ARLINGTON COUNTY, VIRGINIA

**County Board Agenda Item
Meeting of December 12, 2009**

SUBJECT: SP #105 SITE PLAN AMENDMENT for modification to site plan conditions 17 and 18 and modification to location of water fountain, located at 1221, 1301, and 1311 S. Fern St. (RPC #35-003-006, -007, -008).

L1.2

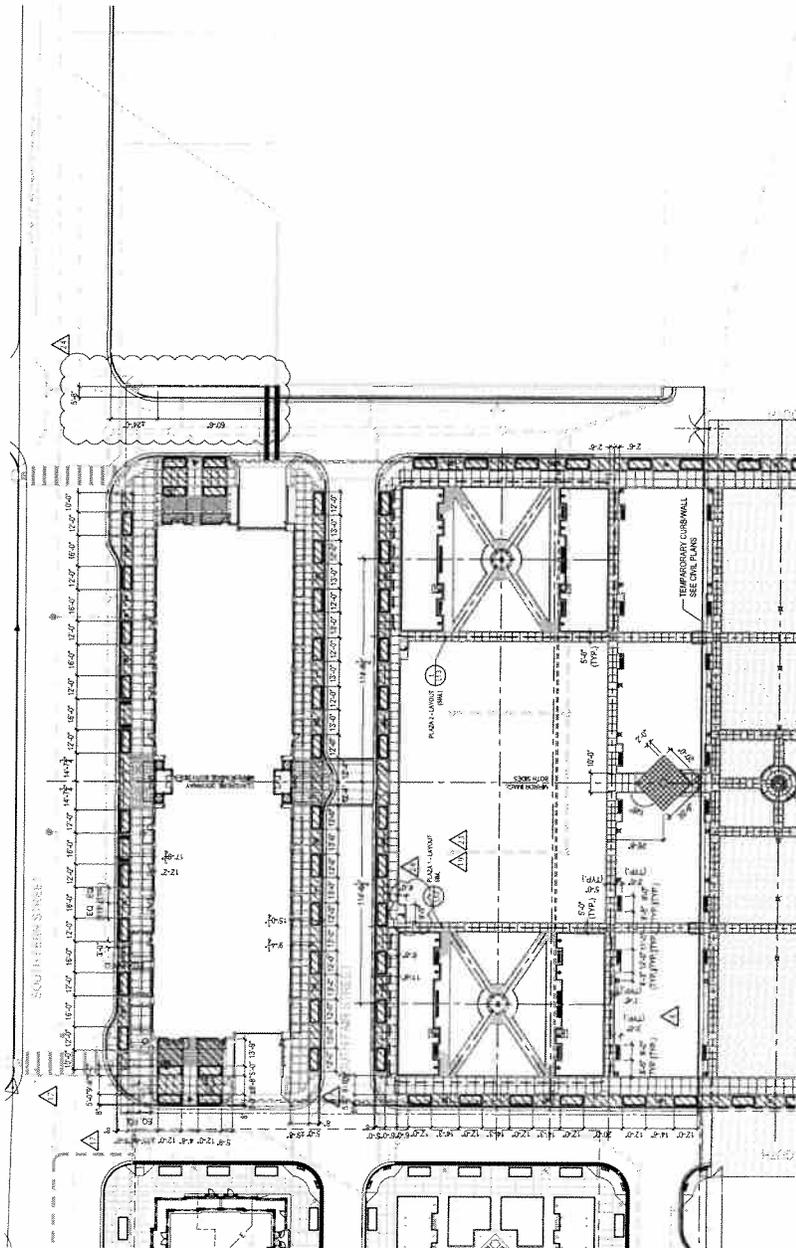
proposes to temporarily relocate the on-street parking adjacent to the proposed sidewalk to the south side of 13th Street South adjacent to the park, which is immediately across the street from where the on-street parking associated with the temporary sidewalk per the condition would have been located. The temporary relocation of the on-street parking would have minimal impact on the parking supply. The shift would also reduce the impact and disruption caused when Metropolitan Park Phase III begins construction, providing a constant supply of parking until Phase III is completed. Further, the applicant has agreed, in lieu of constructing the temporary sidewalk to construct a temporary low retaining wall with plantings between 13th Street South and the existing warehouse wall and incorporate the wall and plantings on the engineering and landscape plans (see attached drawings).
